**CITY OF NEWTON, MASSACHUSETTS
PURCHASING DEPARTMENT
purchasing@newtonma.gov
Fax (617) 796-1227**

**ADDENDUM #2
INVITATION FOR BID #25-29**

ALBEMARLE PLAYGROUND IMPROVEMENTS PHASE I
--

L101

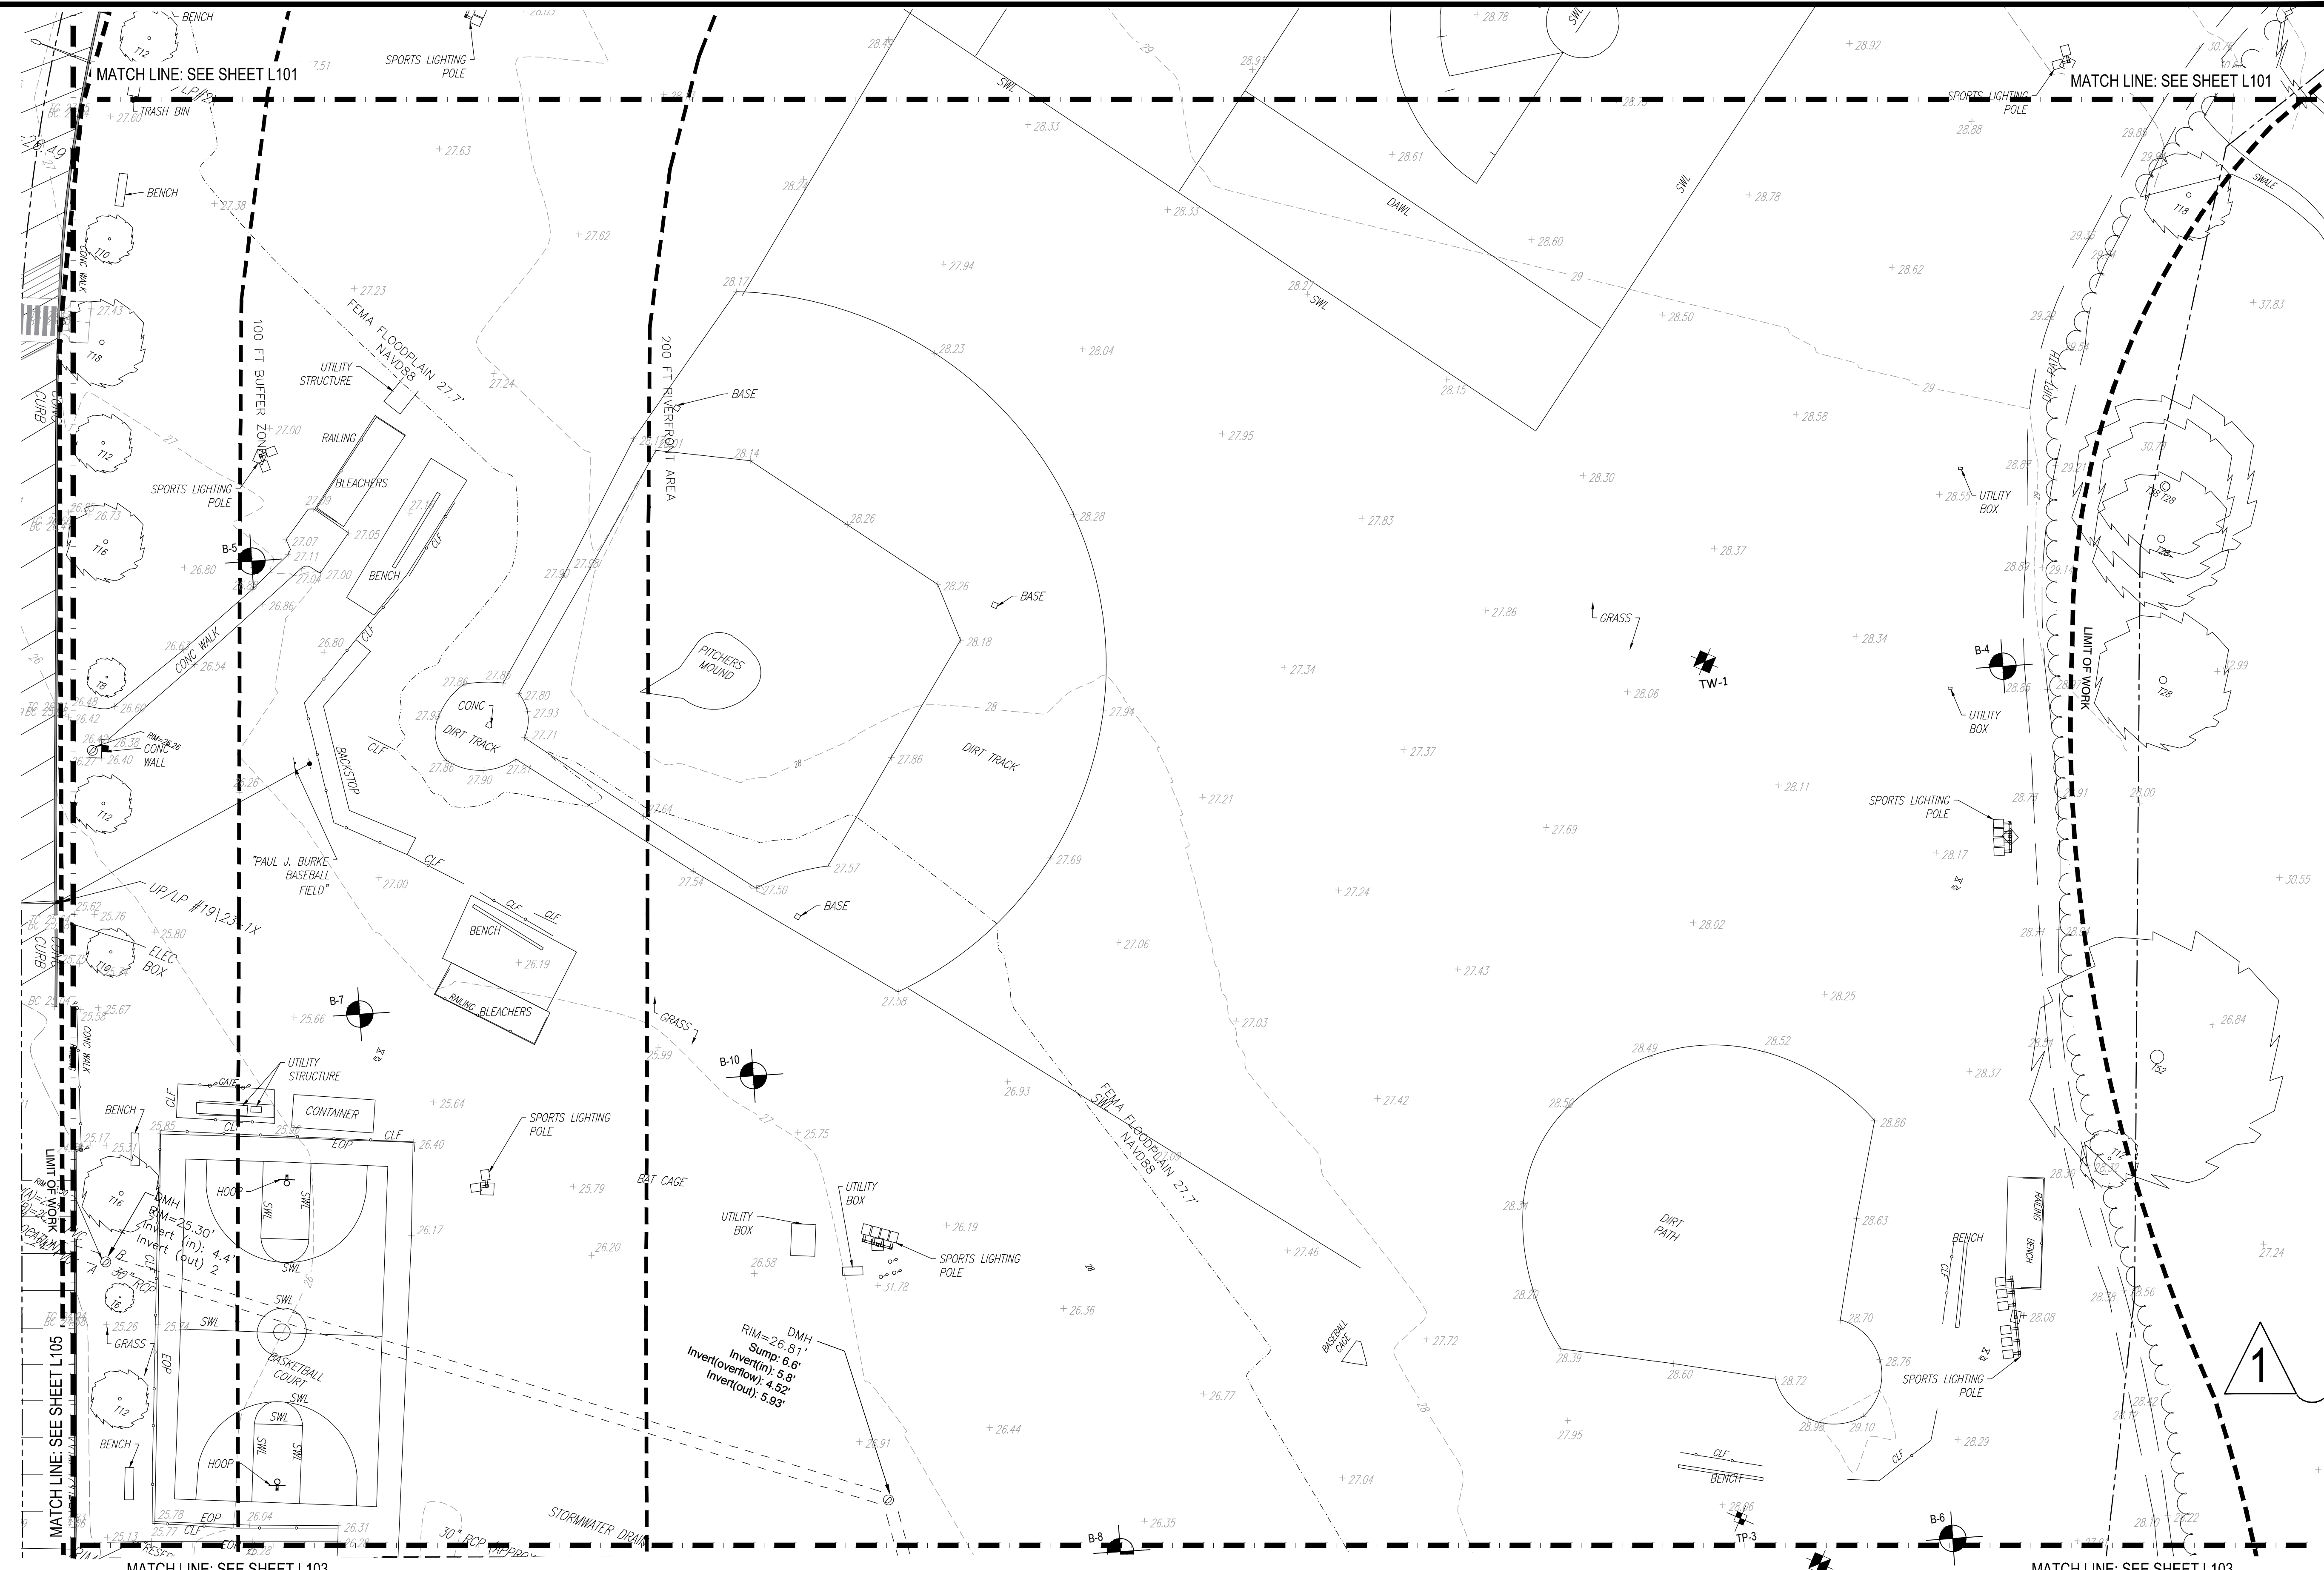
Q8. The existing contour lines do not have elevations on them. Seems like the plan only has spot grades. Can you provide?

A8. See revised Sheets L101, L102, L103, L104 and, L105 per attachment.

2 HOT MIX ASPHALT PAVEMENT, PEDESTRIAN
SCALE: N.T.S.

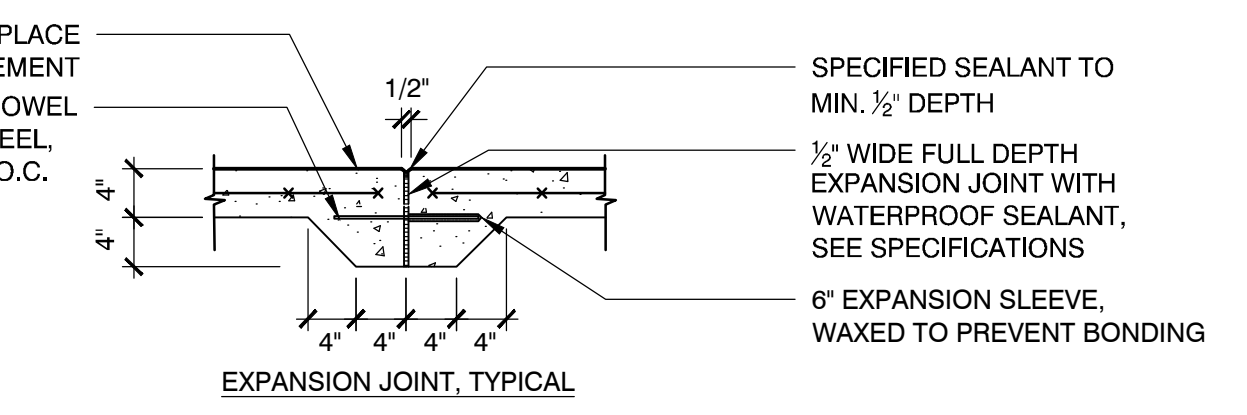
A29. The thickness of the asphalt pavement at the basketball court and pickleball courts in the base bid shall be 3" thick per the pedestrian hot mix asphalt. See detail 2 on sheet L701 in the contract drawings.

10 CAST IN PLACE CONCRETE AT DUGOUT LOCATIONS
SCALE: N.T.S.

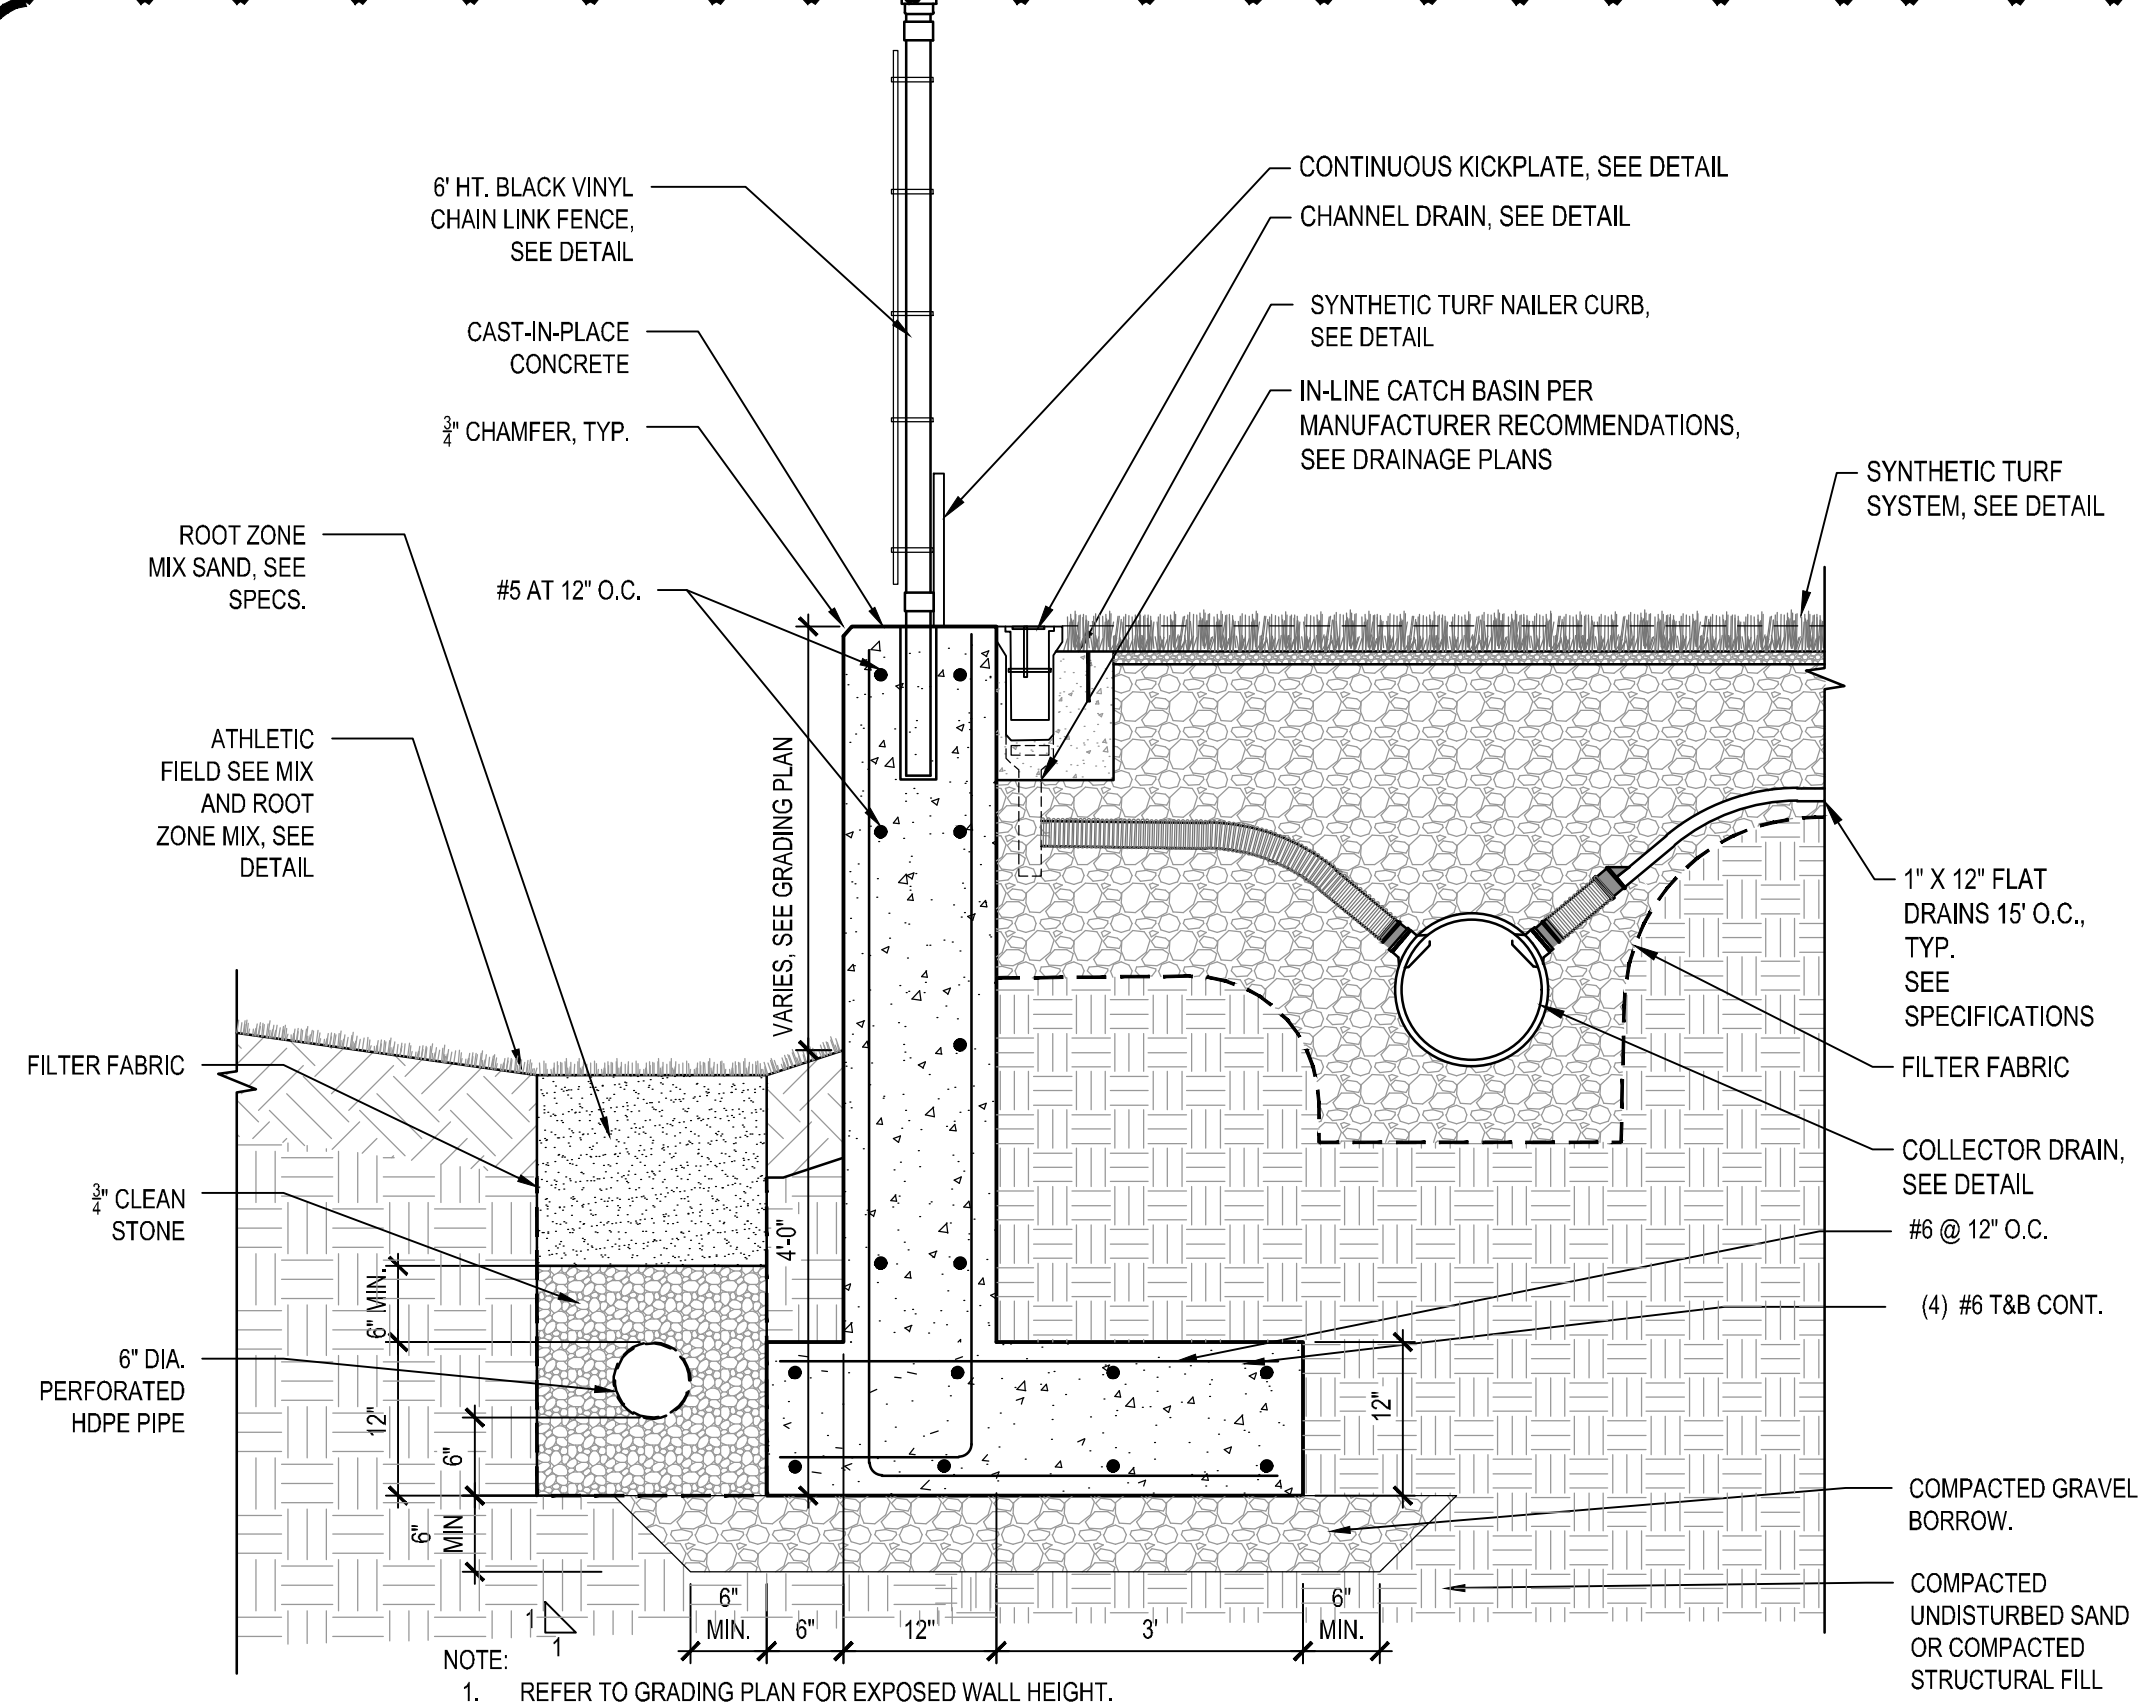
Q30. Please confirm which detail we should use for the dugout slab. Are we to follow details on L705 detail 1 & 4 or detail 10 on L701

A30. The concrete slab for the dugout foundation shall be designed by the manufacturer as shown in detail 10 on sheet L701 and as specified. See the revised sheet L705 in the attachments in this addendum.

12 BVCL FENCE IN CIP CONCRETE RETAINING WALL
SCALE: N.T.S.

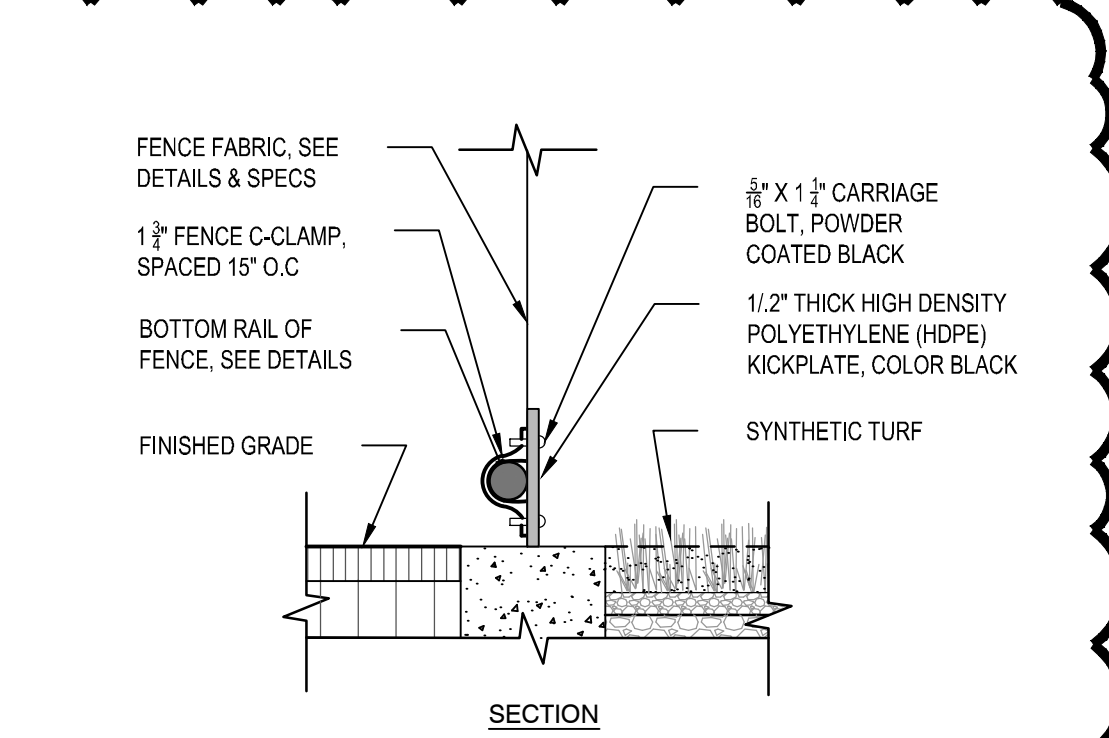
- Detail 12/L701 What is the depth of the wall below grade?
- Detail 13/L701 What is the height of the Kick Plate
- Detail 8/L702 I don't understand this detail. The grading plan shows the exposed height of wall going from 6" reveal to 0" reveal. The detail says that wall below grade is 1.5 times the exposed height. That doesn't make sense to me. Please clarify.
- Can you provide TOW and BOW for the West side

A6. See revised Sheets L701, L702, L501 per the attachments in this addendum.

5 SYNTHETIC TURF BOX COVER
SCALE: N.T.S.

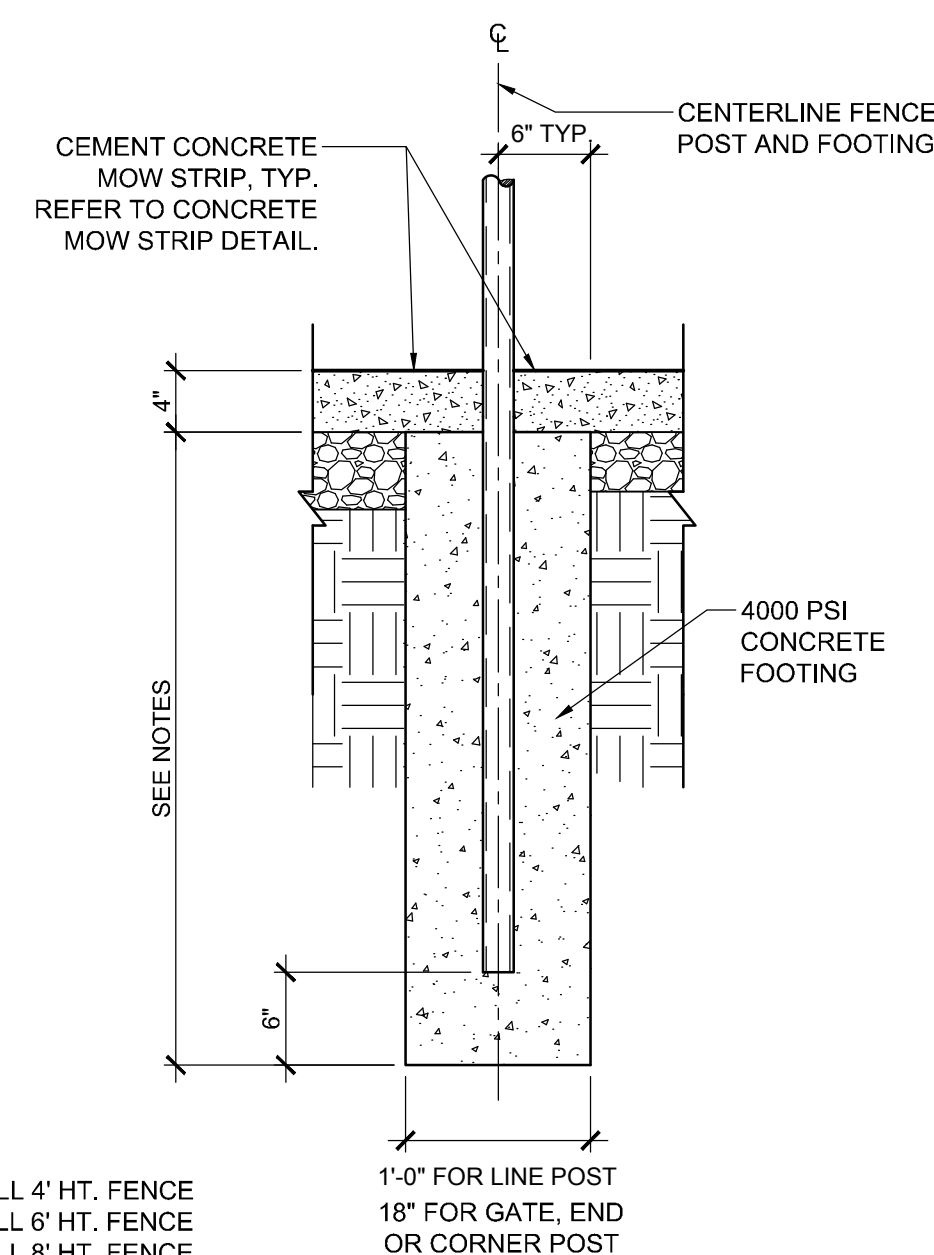
Q5. There is a detail for turf boxes 5/L702. I can't find any on the plans. Can you clarify.

A5. The turf boxes shall be used at outlet control structure #4 because it is the only structure within the turf field. See sheet C100.
